- A. New Propellers for Merc 402-500-650-700
- B. Model 1976 Merc 850 Water Inlet Tube
- C. Service Aids Updated

A. NEW PROPELLERS for MERC 402-500-650-700

B. MODEL 1976 MERC 850 WATER INLET TUBE

Figure 1. Propeller Installation

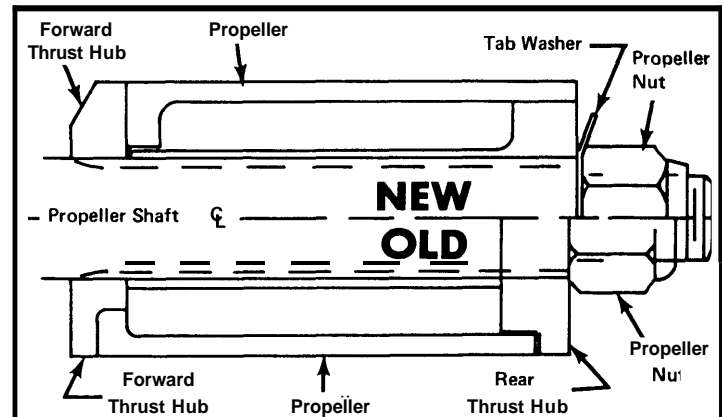
The new line will adapt to any 1970 and newer Merc 402-500-650 (3-Cyl.) model by simply replacing the forward and rear thrust hubs with a new forward thrust hub and tab washer (listed below). (Figure 1)

All 1977 Merc 402-500-700 models (above Serial No. 4564001) will be shipped with the new thrust hub and tab washer that are designed for use with the new propellers. We recommend using the new propellers with these 1977 models; however, the current (1976) propeller line can be utilized if the new forward thrust hub (A-73345) is replaced by the old style forward thrust hub (A-65758), then adding the old rear thrust hub (A-62124A1). (Figure 1)

A-73345 Forward Thrust Hub

A-14-76281 Tab Washer

A-65758 Forward Thrust Hub

A-62124A1 Rear Thrust Hub
